**Invitation to Bid – 2014-012**  
**CONSTRUCTION**  
**Copper River School District - Kenny Lake School**  
**Wood Pellet Boiler Project**  
**Kenny Lake, Alaska**  
**ADDENDUM 5**

Addendum 5 provides additional clarification and answers the questions below:

Sheet No. **C1.0-R**

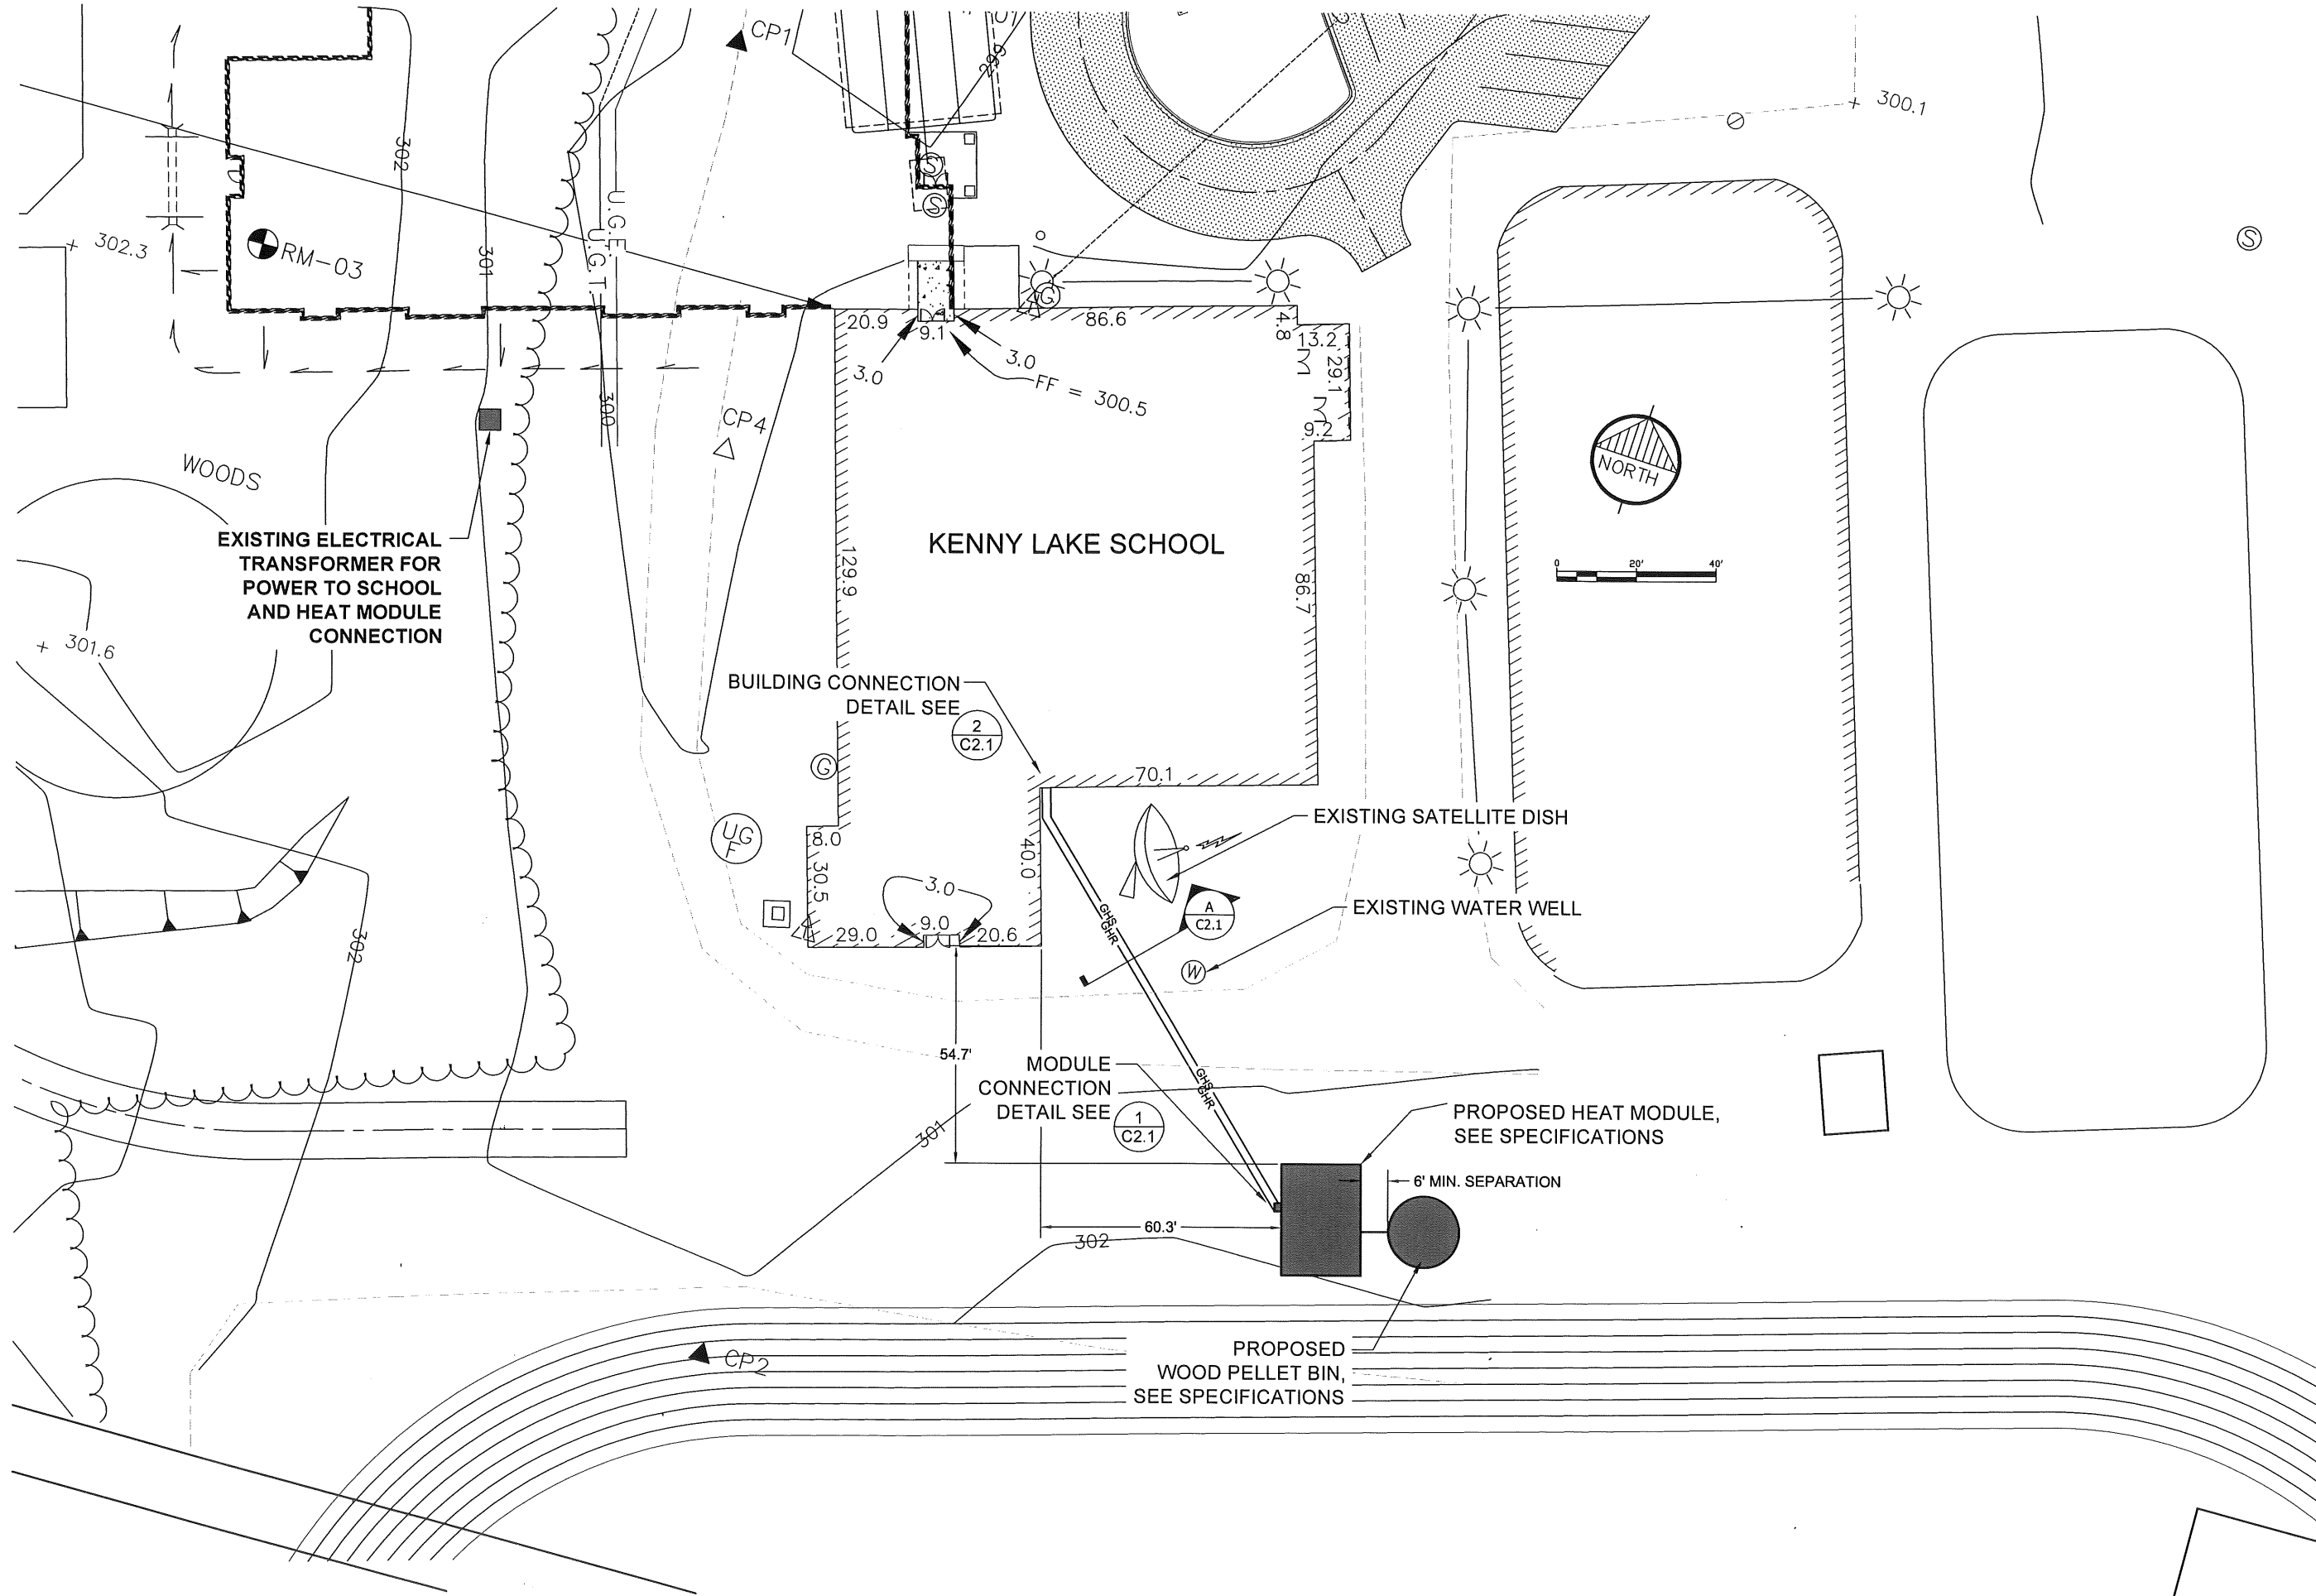
- a. Where indicated "boiler manufacturer", CHANGE to "boiler supplier".
- b. REPLACE: Sheet C1.0, in its entirety, with C1.0-R, attached. It illustrates corrected location of transformer.

- j. The module and wood pellet silo/bin shall be placed on 8 in x 8 in treated wood foundation grade sleepers on the leveled ground specified in the site plan sheet C1.0-R of the Drawings. Contractor may use reinforced concrete foundation. In either case, the load on any portion of the foundation shall not exceed 3000 PSF. Seismic restraints shall be supplied by stainless steel cables attached to the corners of the module
